Agenda
Hearing Examiner Meeting
Thursday, September 15, 2022
Richland City Hall ~ Council Chamber
625 Swift Boulevard
[Zoom](#) ~ Public Telephone Access: (206) 337-9723 or (253) 215-8782
Meeting ID No. 872 2126 7401

S2022-102 Halara Hills Preliminary Plat

Pahlisch Homes LLC has filed a preliminary plat application to divide 59.29 +/- acres into eighty-two (82) residential lots together with eight (8) tracts (open-space and stormwater runoff control). The neighborhood is to be known as the plat of Halara Hills. Access will be provided with the extension of Strawberry Lane into the site that will tee into a loop road formed by new roads: Lamont Street and Redtail Loop.

NATURAL RESOURCES EXISTING CONDITIONS MAP		FIGURE
HALARA HILLS CRITICAL AREAS ASSESSMENT		7A
AKS ENGINEERING & FORESTRY, LLC 2777 NW LOLO DR, STE 150 BEND, OR 97703 541.317.8429 WWW.AKS-ENG.COM		DRWN: RAS CHKD: SKT AKS JOB: 8971

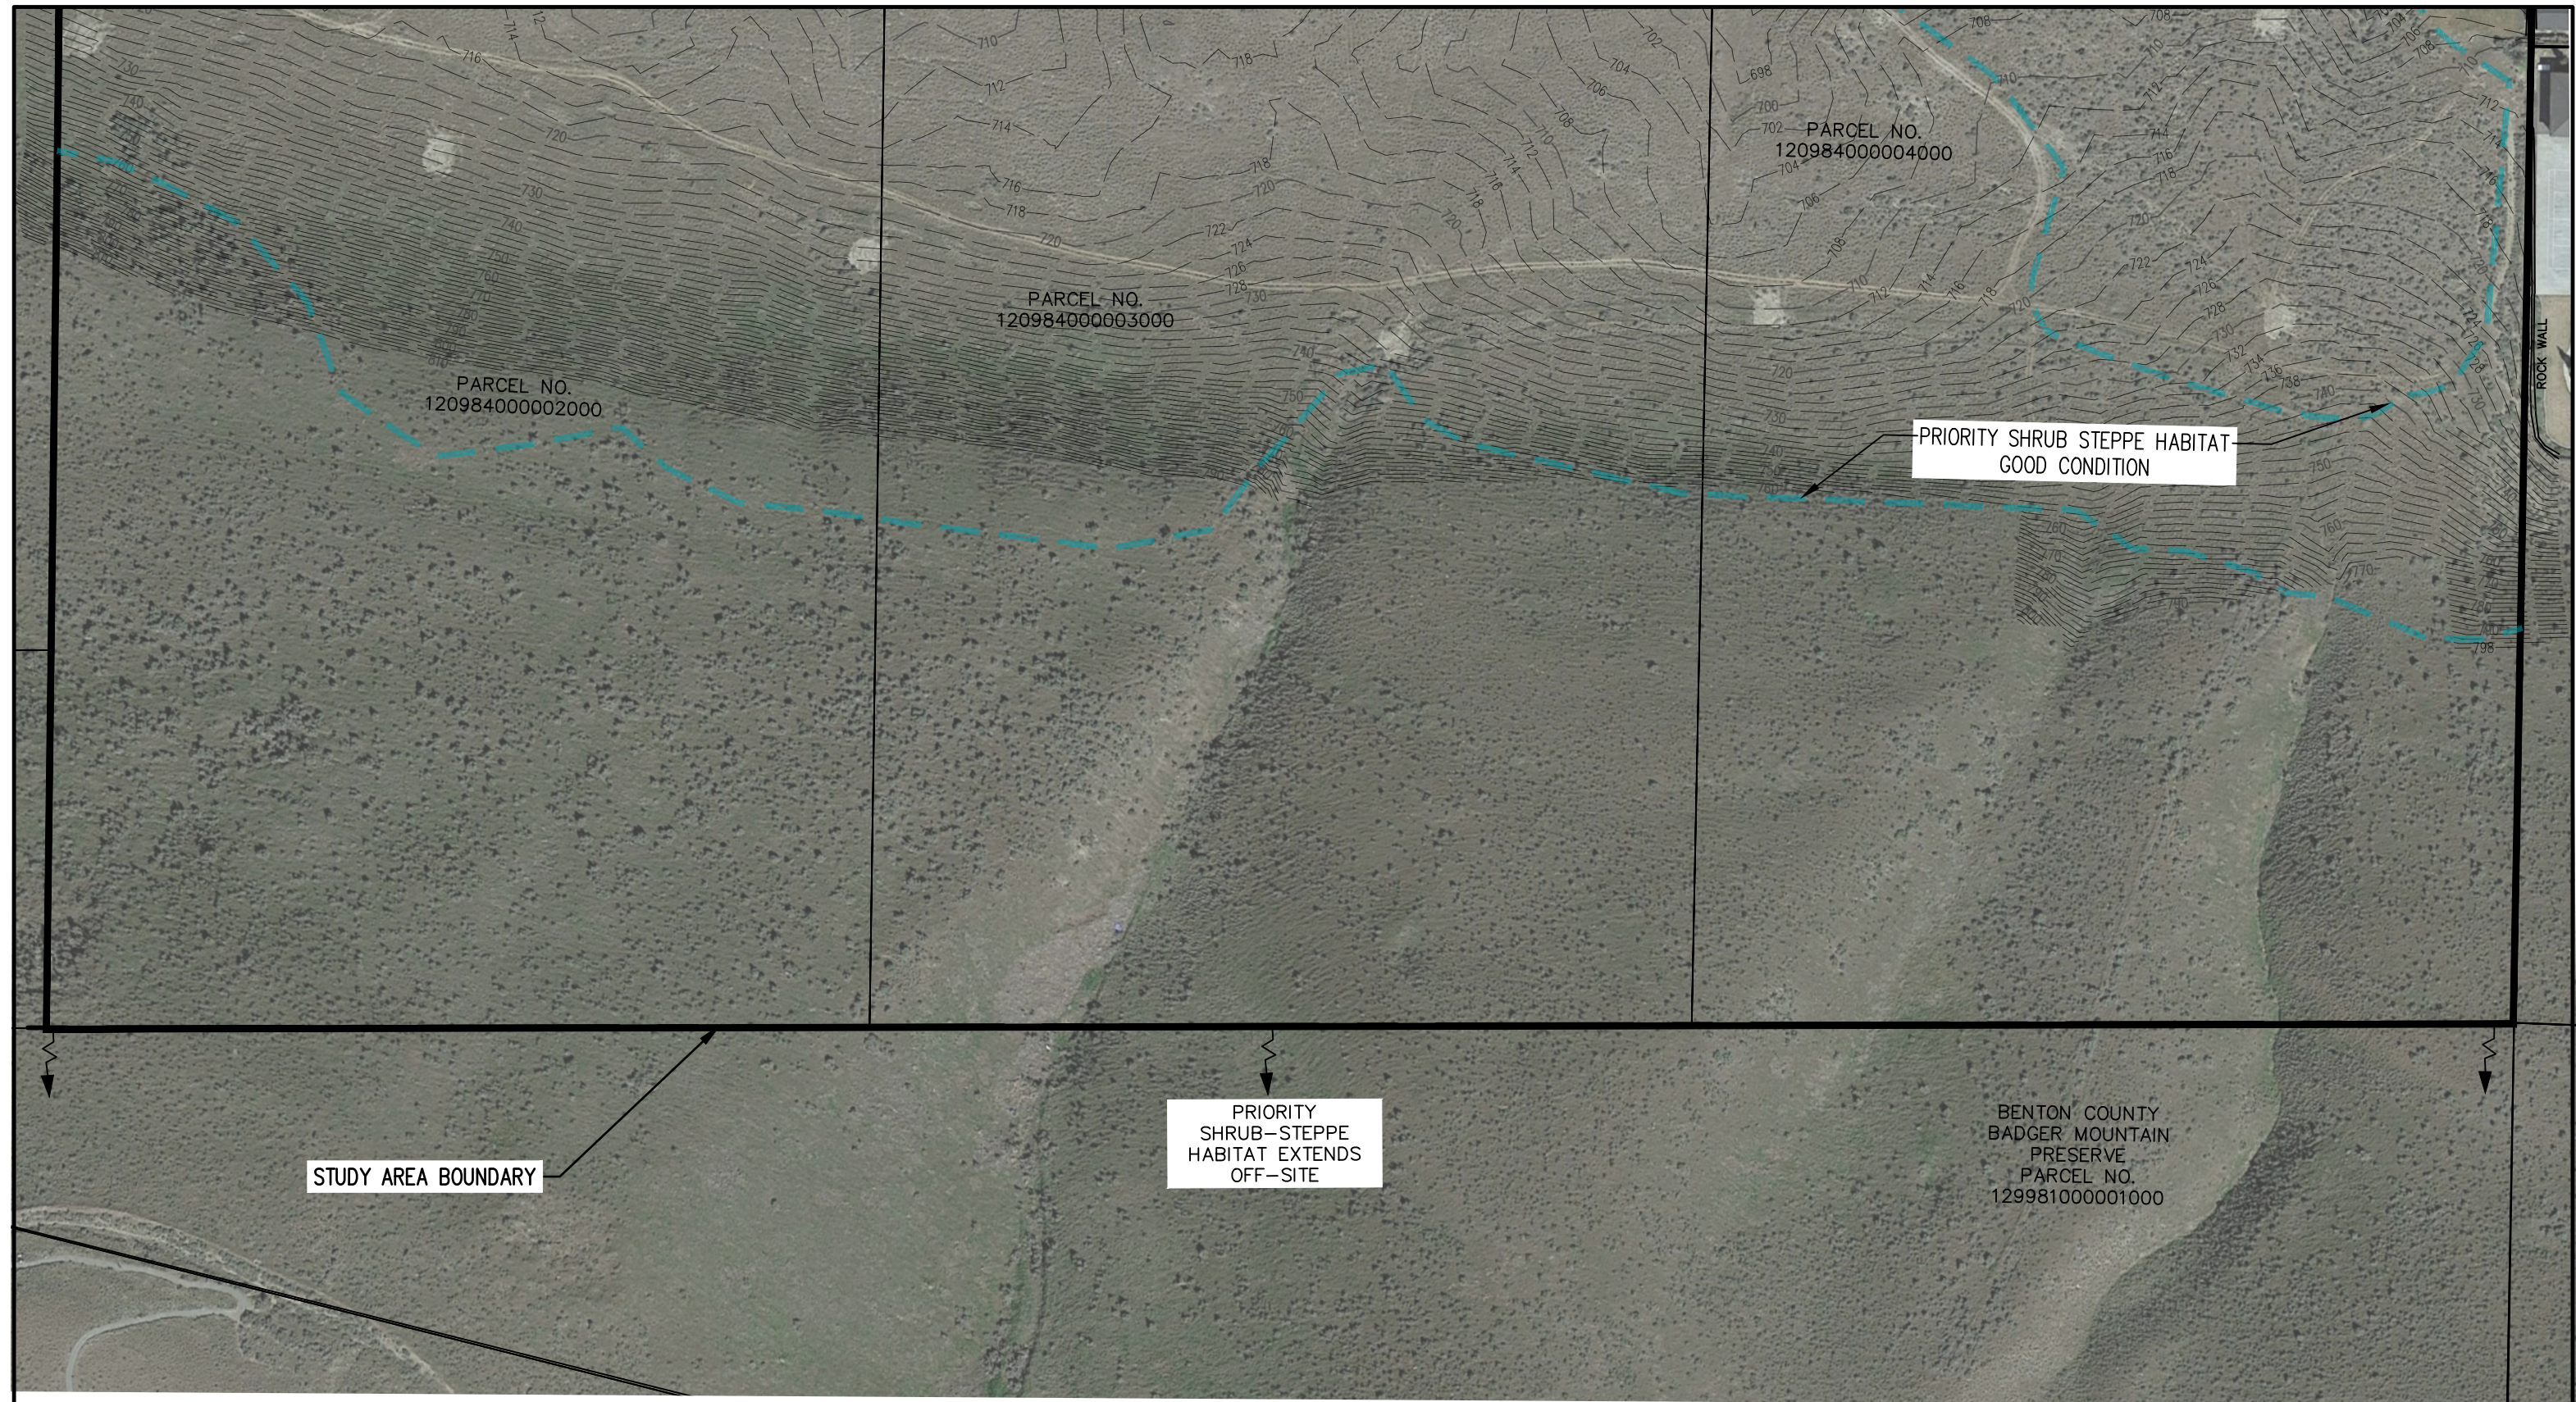
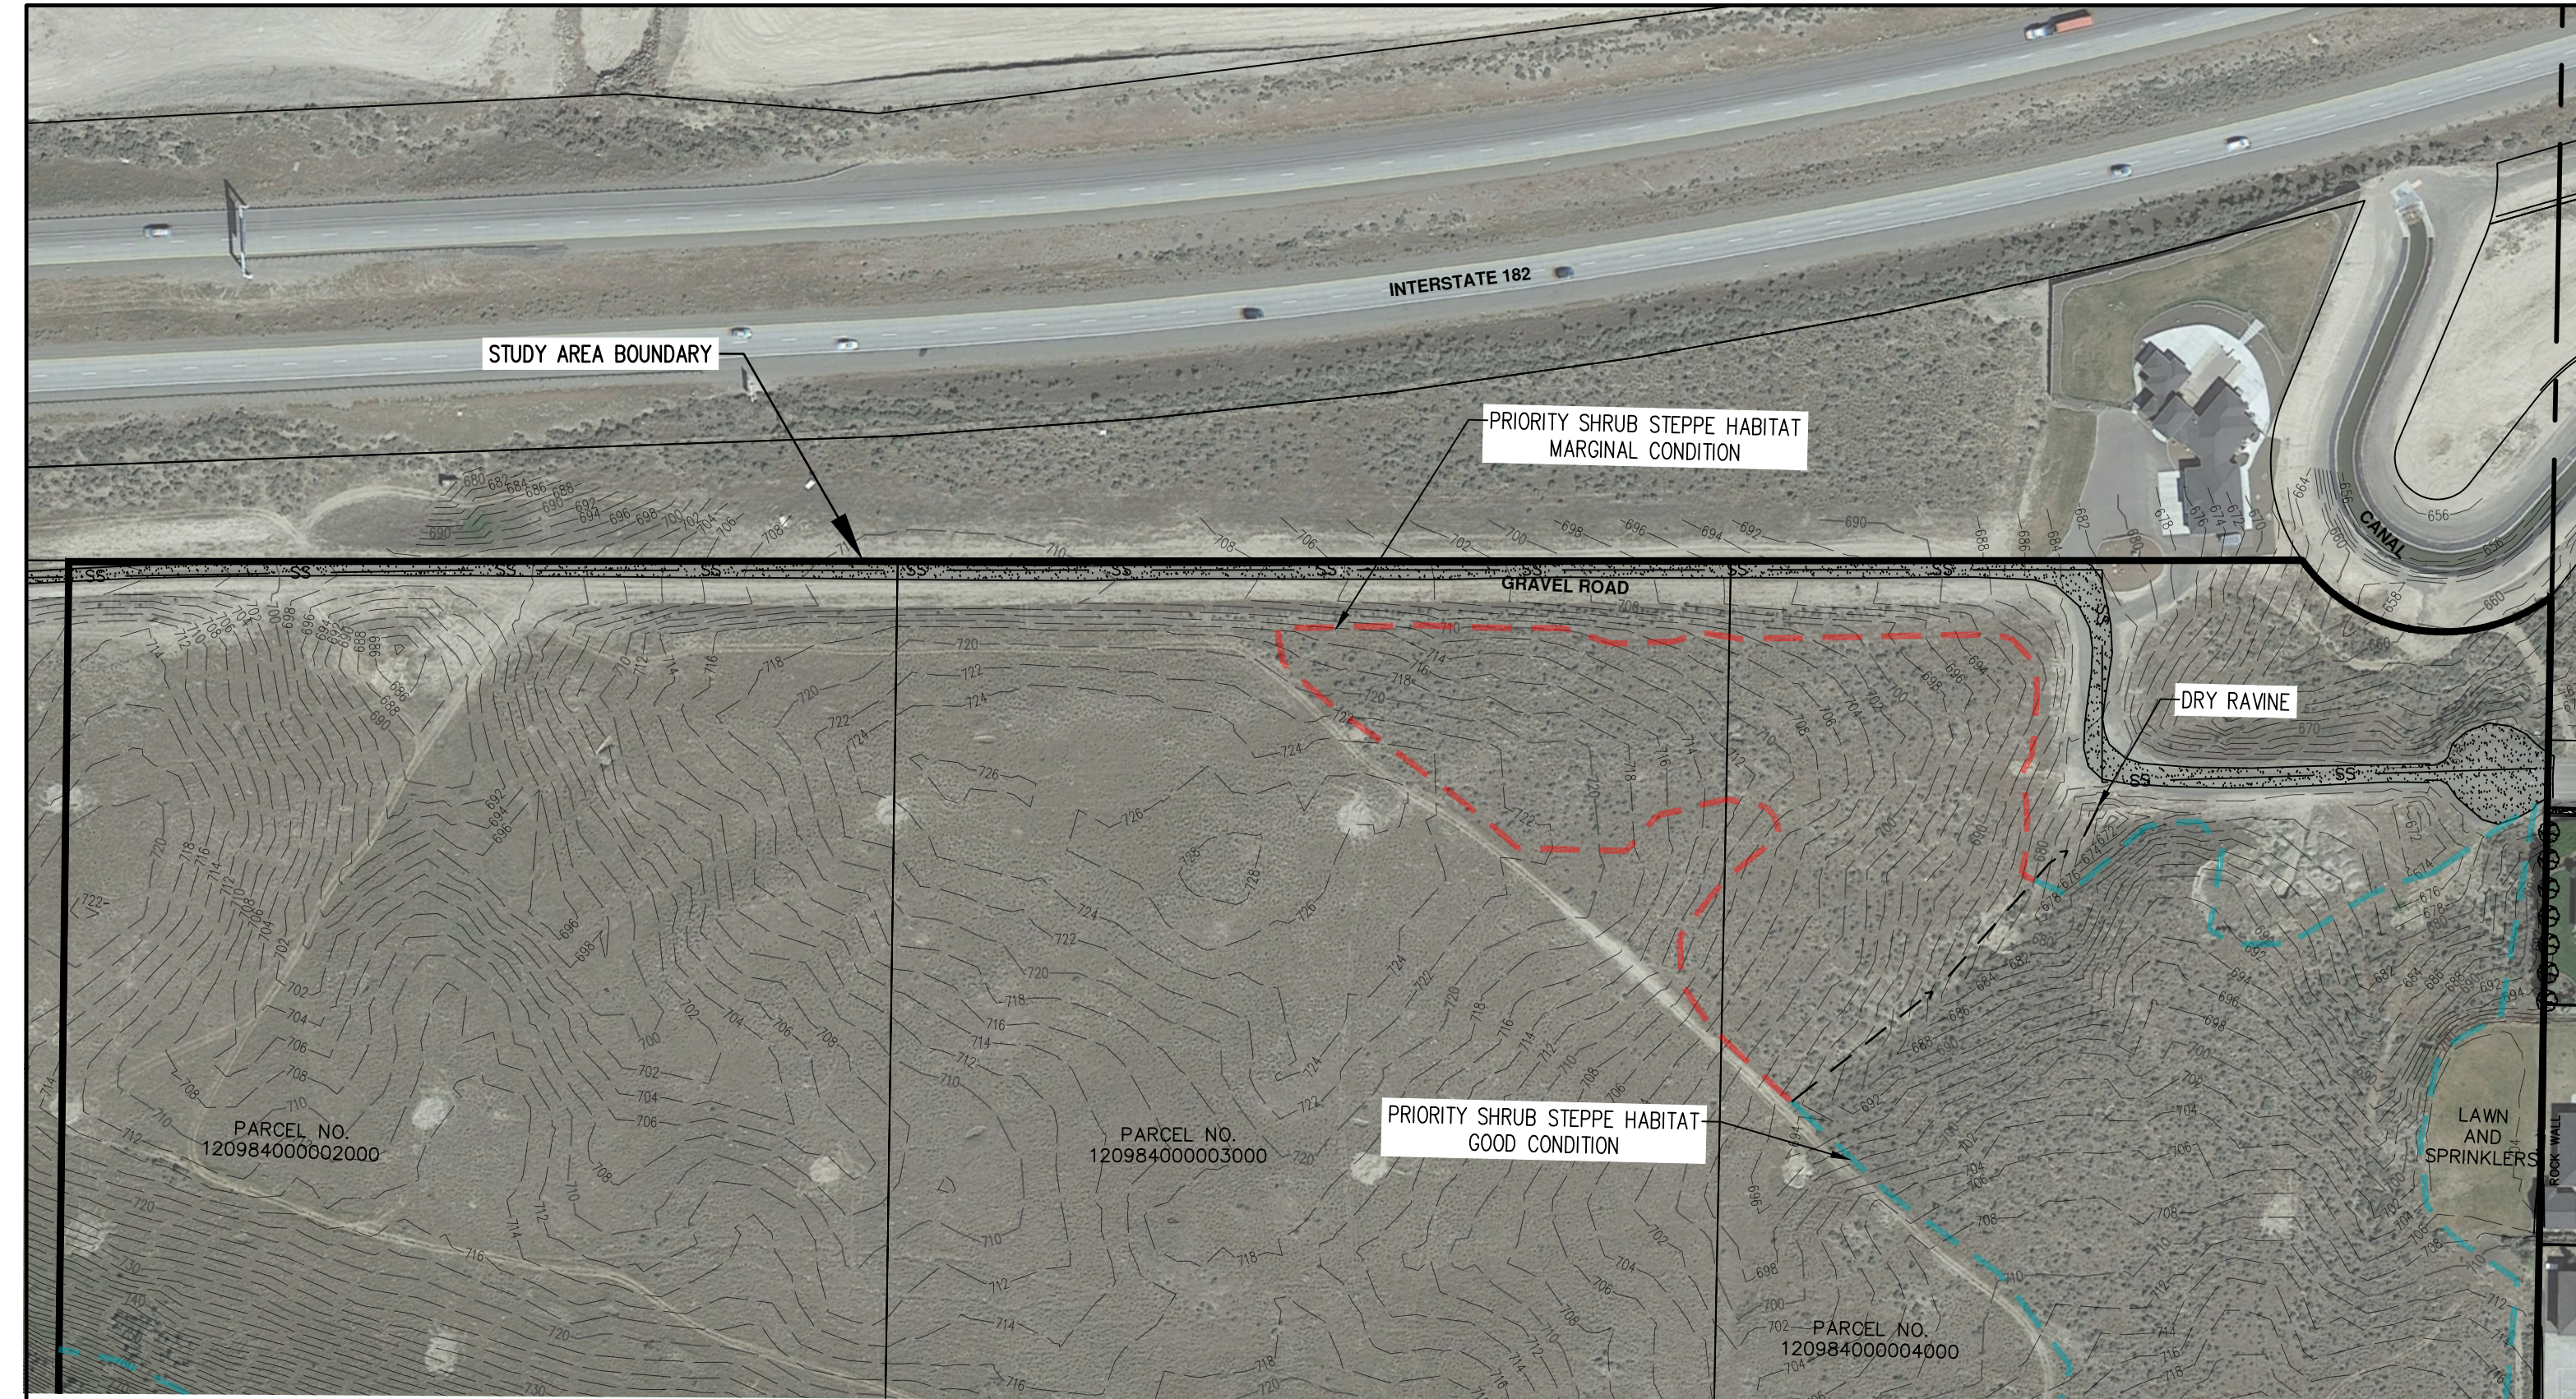
The Richland CAO requires the habitat report to examine “the project area and adjacent lands within 300 feet of the project boundaries”. Figure 7 of the *Habitat Report* clearly shows that areas outside the project boundaries were *not* surveyed.

Figure 3. Site is part of one of largest continuous regions of Shrub steppe in the Tri-Cities Area.

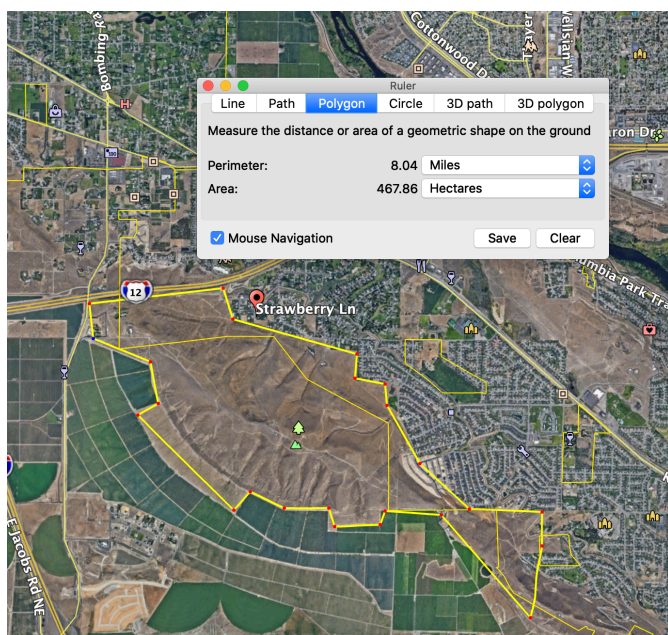
The entire project site is also part of a large tract of shrubsteppe (Figure 3). This habitat is vital since, as noted by WDFW, “With an estimated 80% of historic shrubsteppe lost or degraded to development and agriculture since the arrival of non-native settlers, *protecting remaining shrubsteppe habitats is more important than ever* (emphasis added)”.²⁷

Figure 4. Mature shrubsteppe adjacent and north of site

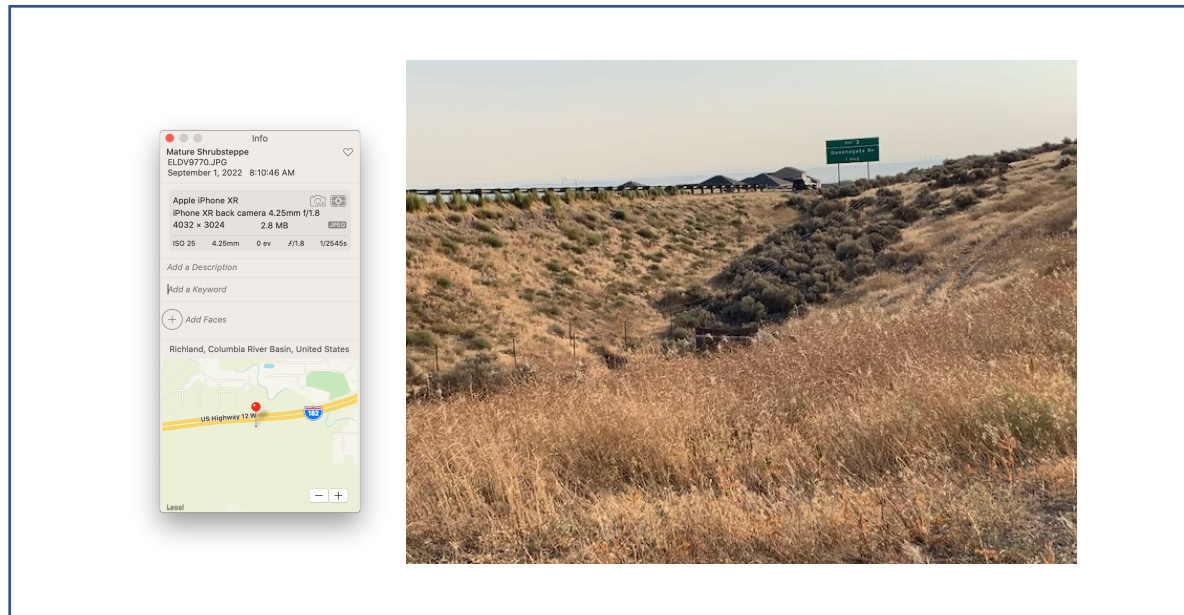
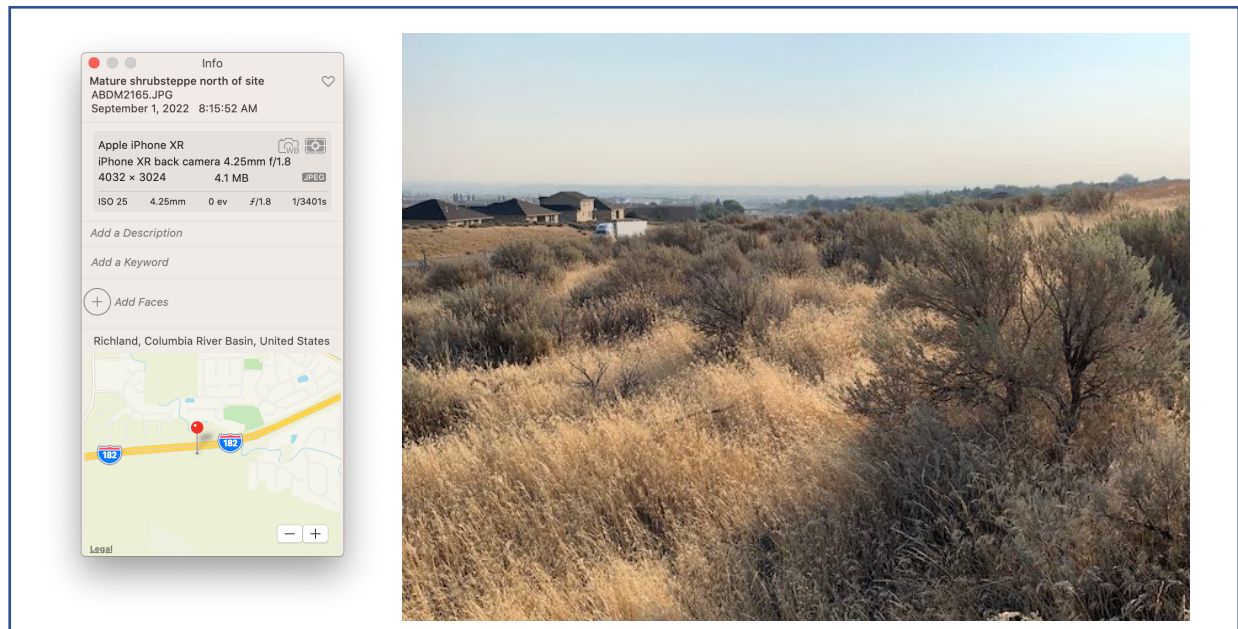
Figure 4 and Figure 5, show mature shrubsteppe immediately adjacent to the site to the north of the site. No survey of this area is included in the *Habitat Report* as required by the Richland

Figure 6. Cryptobiotic crusts, shrubsteppe adjacent to north of site

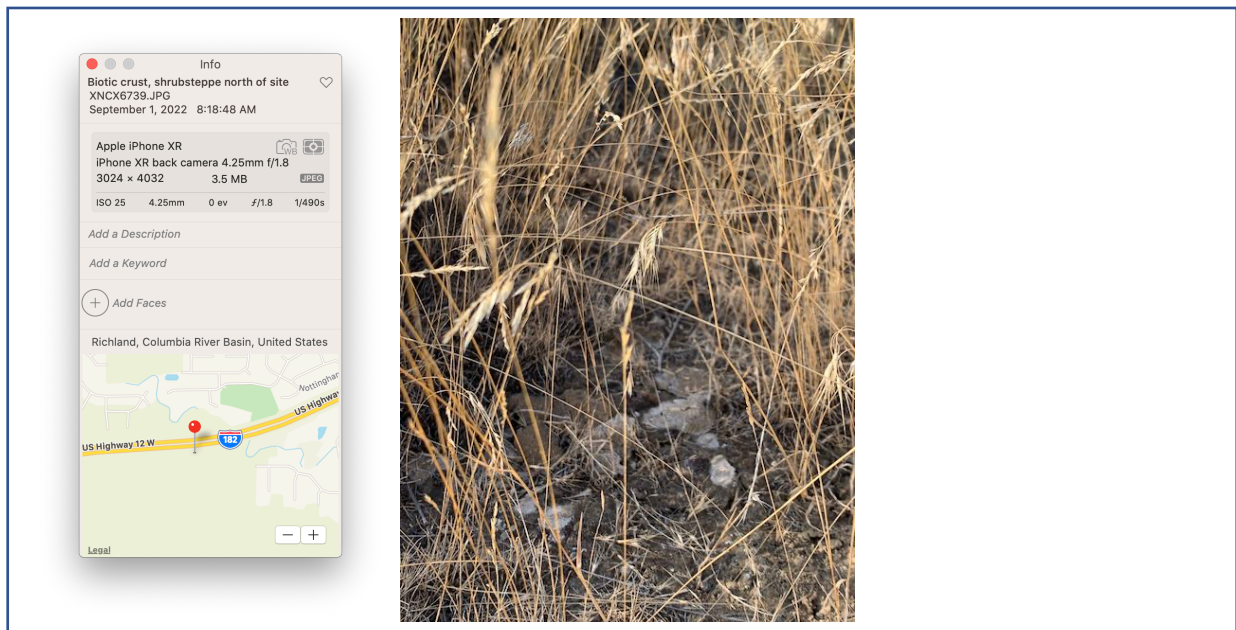
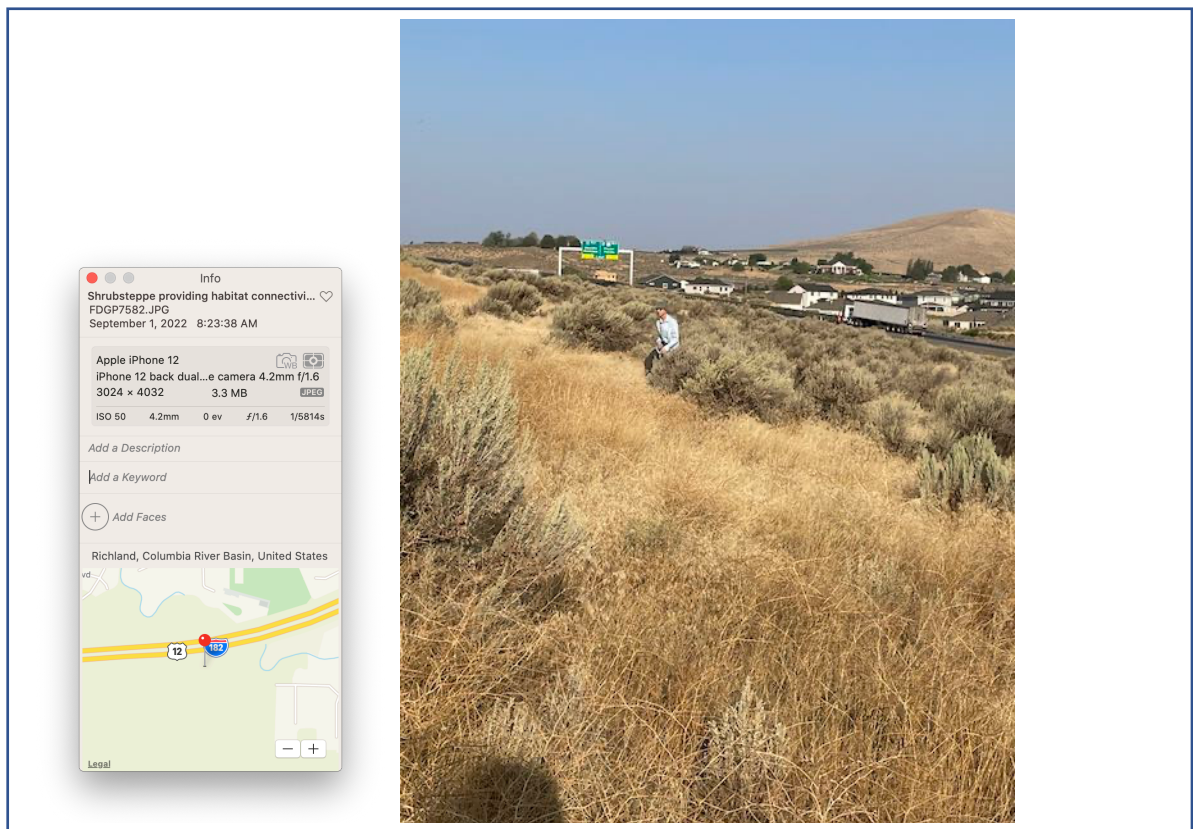
CAO.²⁹ Figure 6 shows this area contains cryptobiotic crusts while Figure 7 gives an overview of the wildlife connectivity provided by this shrubsteppe – assuming it is not further fragmented by development.
